T.I. No.: 2023-18 Updated: -	Subject: Failure of the solid-state relay
---	--

Date: 28/08/2023	Priority	Need for action
Affected machines:	High	As soon as possible
see table „Affected machines“	X Medium	X On next visit to the machine
As of date: Immediately	Low	FYI only

Defective solid-state relays

Figure 2: Faulty production lot

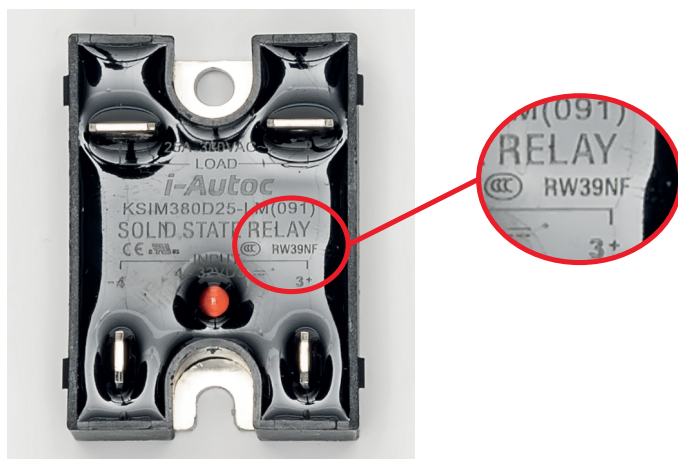
All failed relays are from the same production lot with the **code RW39**. The last two characters (NF in the example) are insignificant, see illustration above.

All machines delivered from calendar week 35/2023 onwards are explicitly checked at Schaerer for SSR with **production code RW39**.

- ▶ Check the production code of the solid-state relays.
- ▶ If the relays are from the **RW39 lot**: Replace all relays.

- ▶ Check the spare parts stock for the presence of solid-state relays with **production code RW39**.
- ▶ Sort out solid-state relays with **production code RW39**.
- ▶ Machines in stock: Check machines in stock before or during installation.
